AGENDA
March 24, 2015

DEVELOPMENT REVIEW

DATE: 3/11/2015
TO: Lynn
FROM: Gregg Folk
RE: Countryside Meadows Preliminary Plat

Plat Review

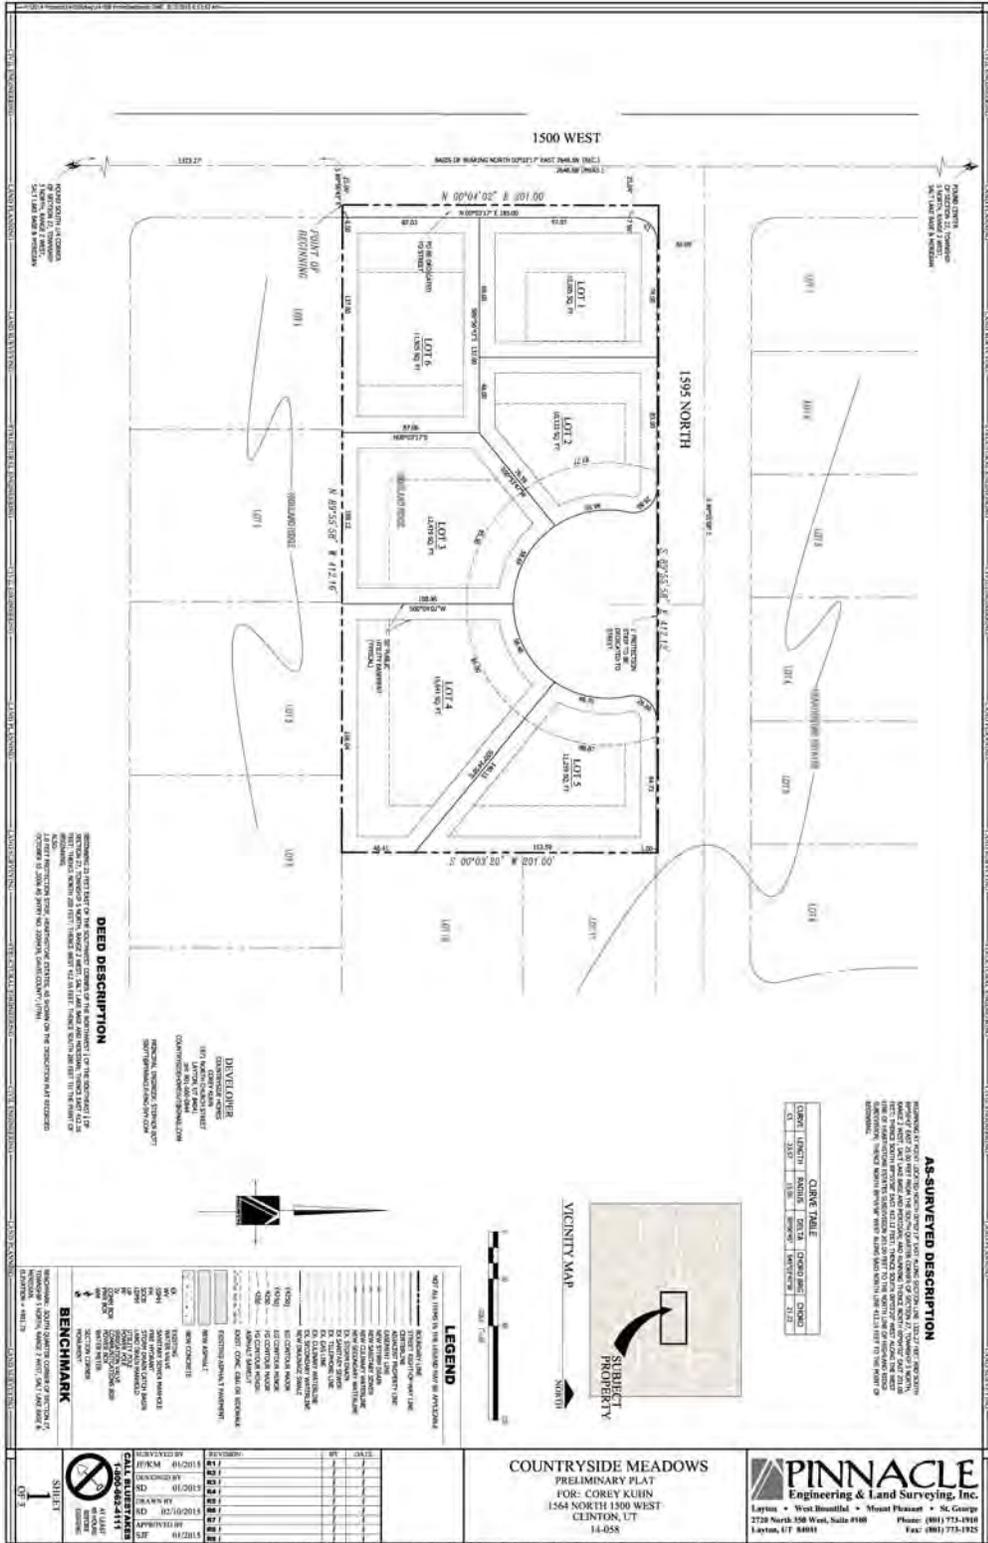
- Submittal Date: 2-12-15
- Sewer and Land drain needs 5' manhole at existing main connections
- Add catch basin at start of east radius
- Install 8" W valve at mainline connection
- Move W blow off to parkstrip lot 3/4 property line
- Where are lot 1 utilities fed from?
- SWPPP needs to be provided
- Street light at West radius
- Remove/replace asphalt from radius to radius across entire road to curb to the North

1. In the typically roadway cross section the base course section does not meet the current city requirements.
